February 22, 2021

**Re: Comments of Horizon West Transmission, LLC on the Draft Environmental Impact Report for the Estrella Substation and Paso Robles Area Reinforcement Project, December 2020 (California State Clearinghouse No. 2018072071)**

TA PROJECTS\17010\_CPUC\_Estrella\_Task\_3\_EIR\mxd\Chapter 2\Eig\_2-7\_ProjectOverview\_11x17.mxd 7/16/2020 PG

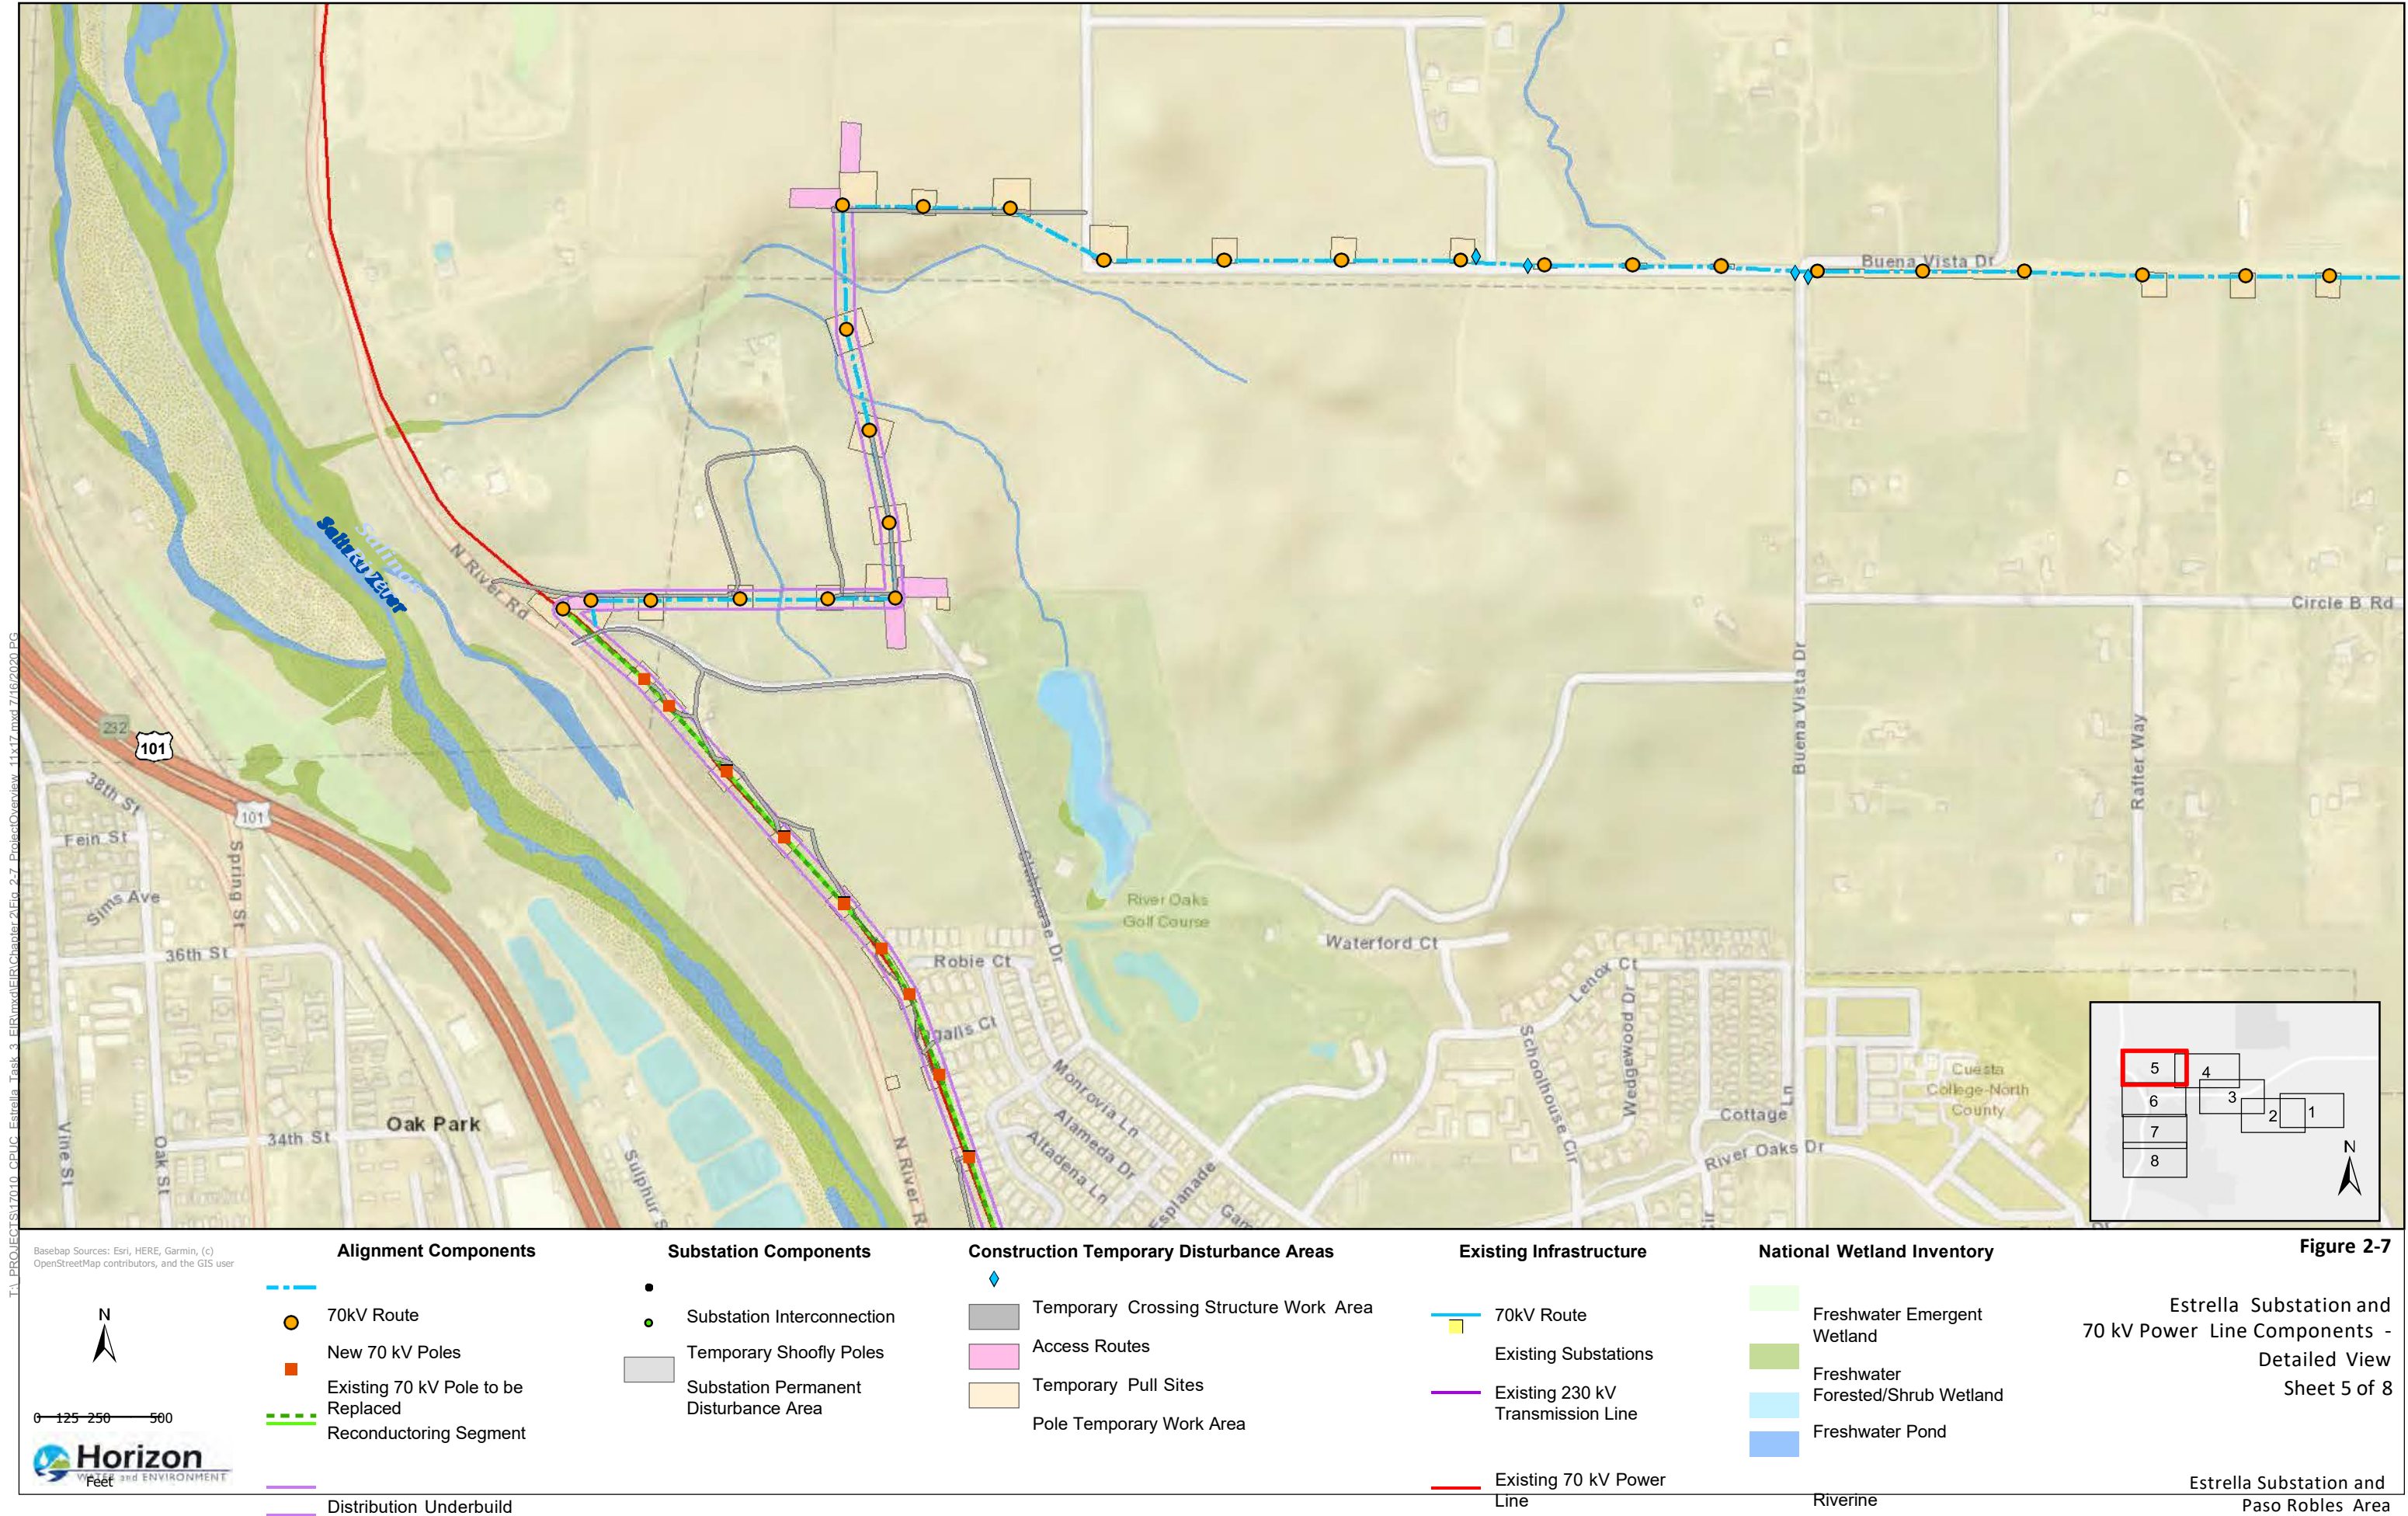
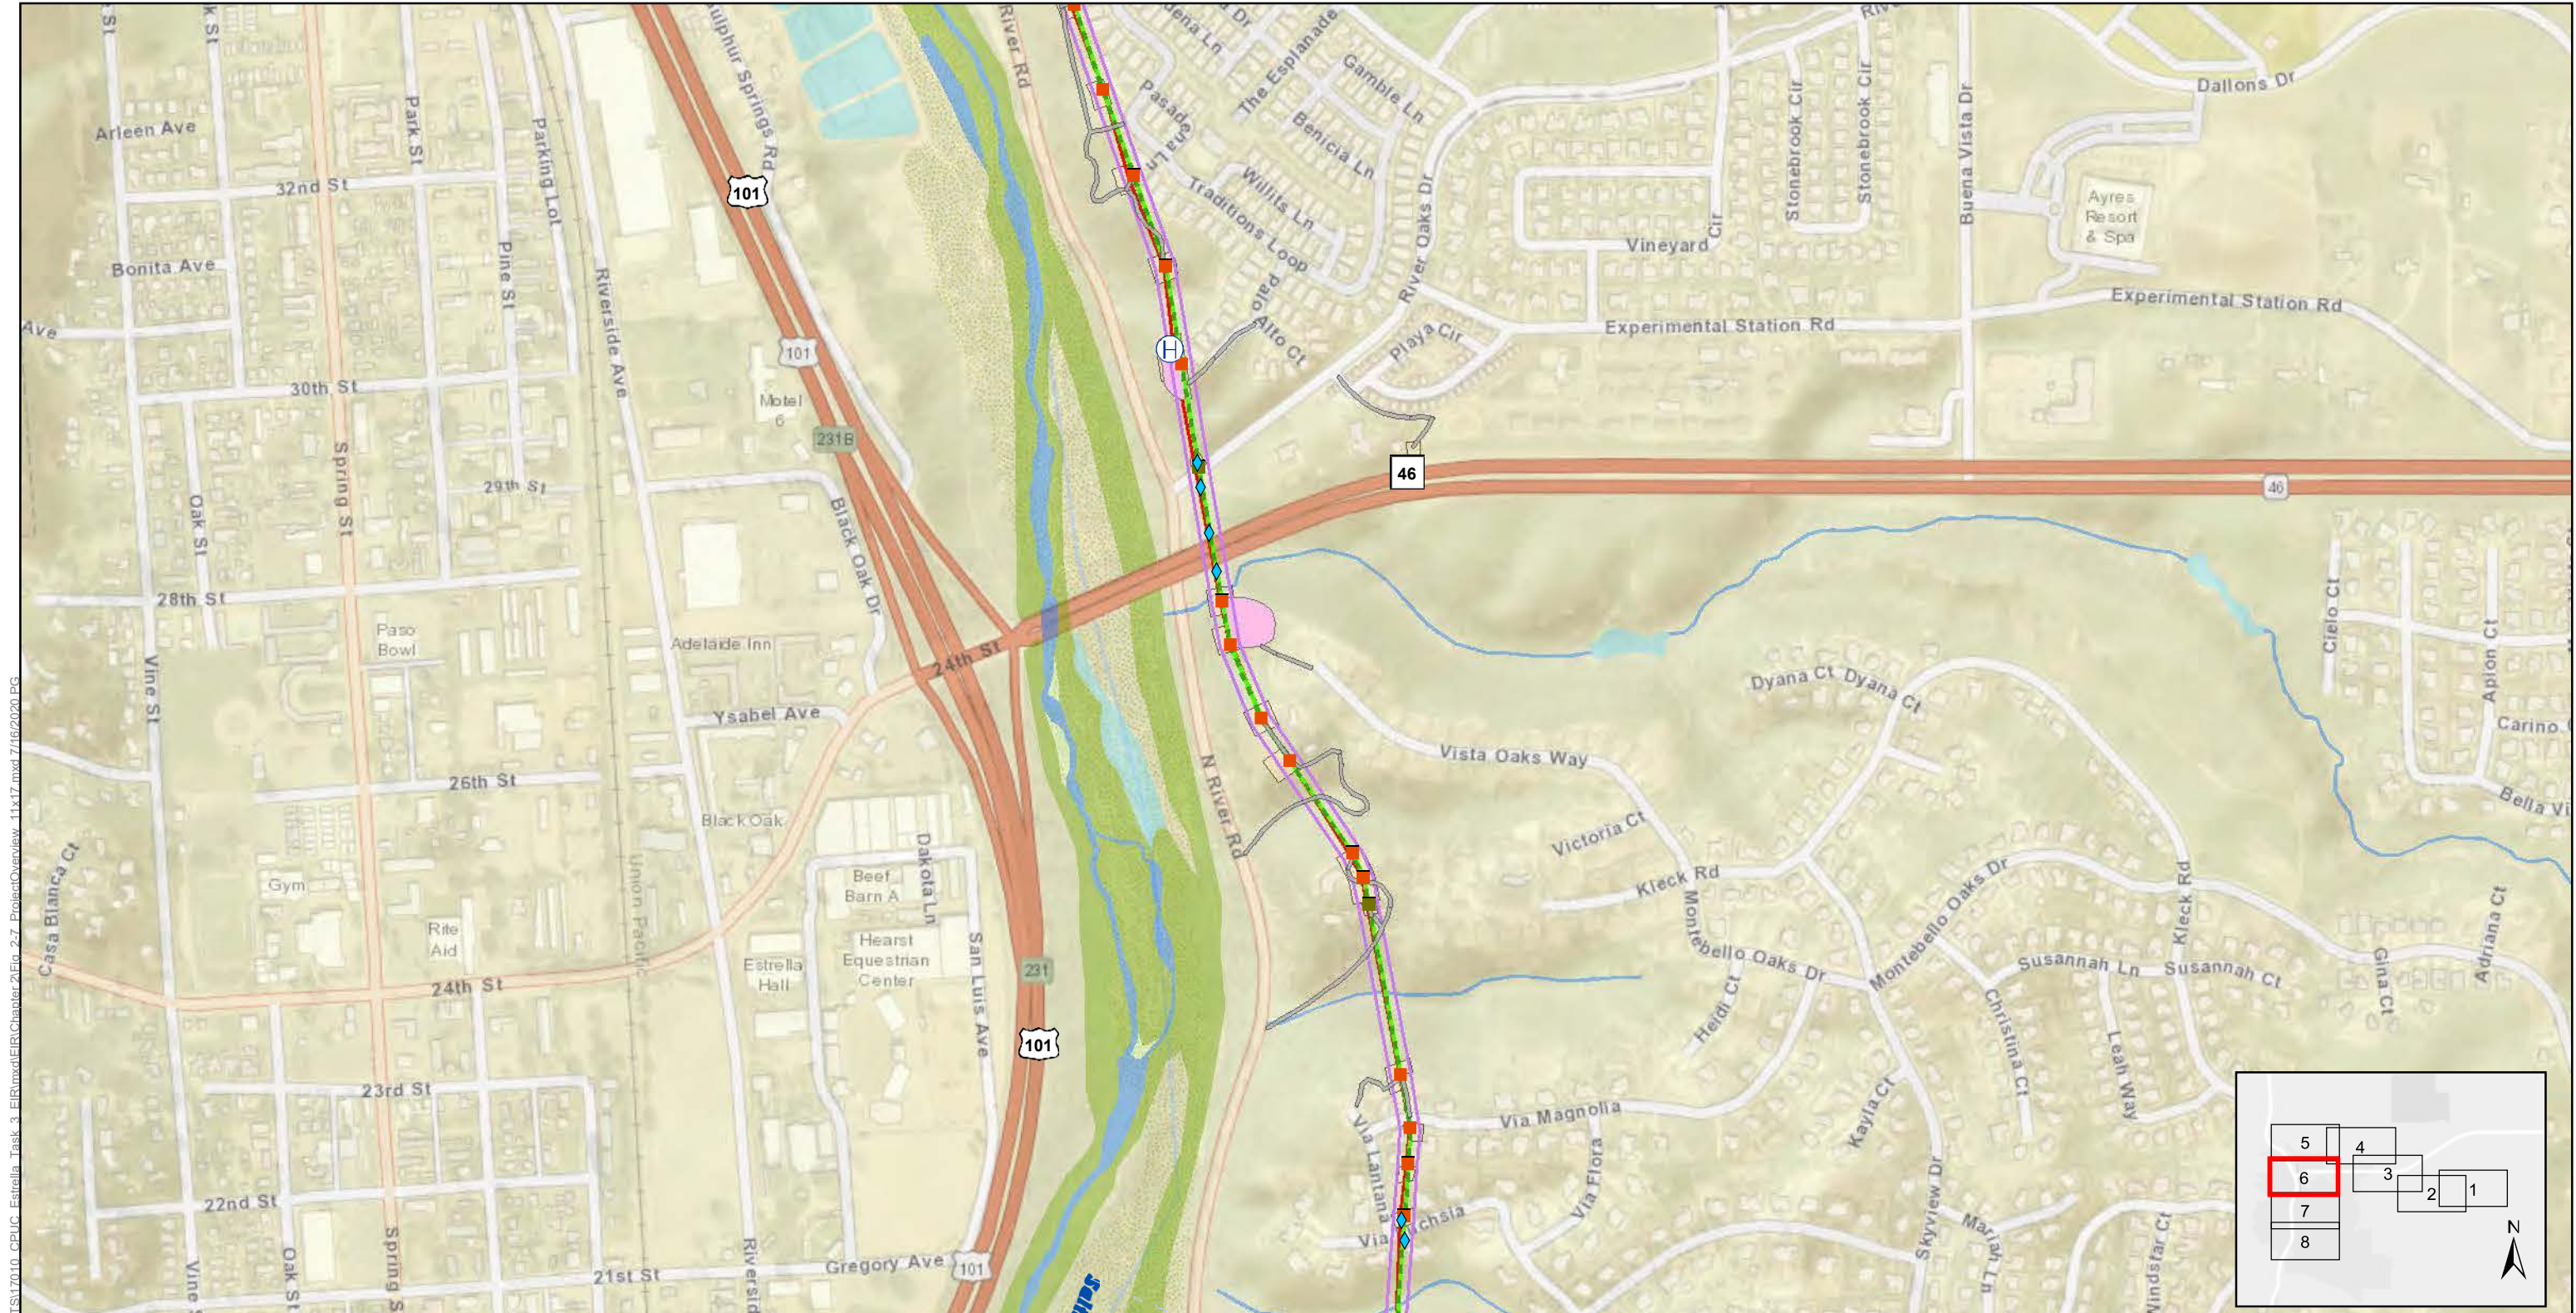
2-22	Figure 2-7	Replace figure to include new substation parcel and update temporary and permanent disturbance areas
2-46	Figure 2-11	Replace figure with new substation layout
2-47	Figure 2-12	Replace figure with new substation layout
2-48	Figure 2-13	Replace figure with new substation layout
2-49	The fenced portion of the 230 kV substation would be approximately 4 acres in size. An approximately 7-foot-tall chain-link fence with an additional 1 foot of barbed wire would be installed around the remaining perimeter of the 230 kV substation.	<p>Please revise text to read:</p> <p>The fenced portion of the 230 kV substation would be approximately 4 acres in size. <del>An approximately 7-foot-tall</del> chain-link fence, <u>a minimum of 7 feet tall</u>, with an additional 1 foot of barbed wire would be installed around the remaining perimeter of the 230 kV substation.</p>
2-56	The equipment and facilities associated with ultimate substation buildout would primarily be placed within the fence line of the already-constructed Estrella Substation. The anticipated layout of the Estrella Substation at ultimate buildout is shown in Figure 2-18. The additional 230/70 kV transformer under ultimate buildout is assumed to include the same amount of mineral oil (16,000 to 18,000 gallons) as described for the Proposed Project (see Section 2.3.1), and the same secondary containment structure (i.e., designed to allow sufficient freeboard to include the oil volume of the transformer plus the precipitation from a 25-year, 24-hour storm event). The additional 230 kV interconnection is assumed to include similar structures (LSTs) and follow a similar interconnection process to that described for the Proposed Project in Section 2.3.1 under the header for “230 kV Transmission Interconnection.” The additional 70/21 kV transformers that may be installed to support additional distribution feeders are assumed to include secondary containment, as necessary to contain spills of any stored mineral oil.	<p>Please revise text to read:</p> <p>The equipment and facilities associated with ultimate substation buildout would primarily be placed within the fence line of the already-constructed Estrella Substation. The anticipated layout of the Estrella Substation at ultimate buildout is shown in Figure 2-18. The additional 230/70 kV transformer under ultimate buildout is assumed to include the same amount of mineral oil (16,000 to 18,000 gallons) as described for the Proposed Project (see Section 2.3.1), and the same secondary containment structure (i.e., designed to allow sufficient freeboard to include the oil volume of the transformer plus the precipitation from a 25-year, 24-hour storm event). The additional 230 kV interconnection is assumed to include similar structures (LSTs) and follow a similar interconnection process to that described for the Proposed Project in Section 2.3.1 under the header for “230 kV Transmission Interconnection.” The additional 70/21 kV transformers that may be installed to support additional distribution feeders are assumed to include secondary containment, as necessary to contain spills of any stored mineral oil.</p>
